Access Compliance Report

Public Rights-of-Way

(Curb Ramps)

Intersection ID: 17085	Main Street: CROYDON_RD	Cross Street: SELWYN_AV	Location: SW
ADA ID: 2718517AFBEC	Ramp Type: PerpDiag	Initial Pass/Fail: Fail	Overall Compliance: No
		Severity Score: 12.5

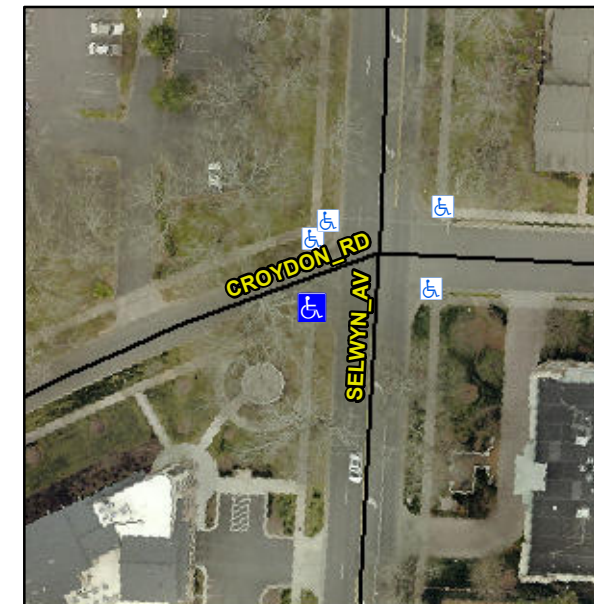
Compliance	Description	Data	Compliance	Description	Data
N/A	Ramp Length (in)	72.0	No	Ramp Slope (%)	11.5
Yes	Ramp Width (in)	84.0	Yes	Ramp XSlope (%)	0.1
N/A	Flare Type LT	N/A	N/A	Flare Type RT	N/A
N/A	Flare Slope LT (%)	N/A	N/A	Flare Slope RT (%)	N/A
N/A	Flare Traversable LT?	N/A	N/A	Flare Traversable RT?	N/A
N/A	Landing Length (in)	N/A	N/A	DWS Provided?	N/A
N/A	Landing Width (in)	N/A	N/A	DWS Contrast?	N/A
N/A	Landing Slope (%)	N/A	N/A	DWS Length (in)	N/A
N/A	Landing X Slope (%)	N/A	N/A	DWS Full Width?	N/A
N/A	Landing Curb? (Y/N)	N/A	N/A	DWS Offset (in)	N/A
N/A	Shared Landing?	N/A			
N/A	Gutter Ponding?	N/A	N/A	Gutter Slope (%)	N/A
N/A	Gutter Lip Ht (in)	N/A	N/A	Gutter X Slope (%)	N/A
N/A	Painted X Walk1?	No	N/A	Painted X Walk2?	No
	X Walk 1 Direction	To E		X Walk 2 Direction	To NE
N/A	X Walk 1 Width (in)	N/A	N/A	X Walk 2 Width (in)	N/A
	X Walk 1 Slope (%)	1.4		X Walk 2 Slope (%)	0.6
	X Walk 1 X Slope (%)	1.8		X Walk 2 X Slope (%)	1.3

Remove & Replace Curb Ramp With Two New Directional Ramps or Equivalent.

R304.2.2
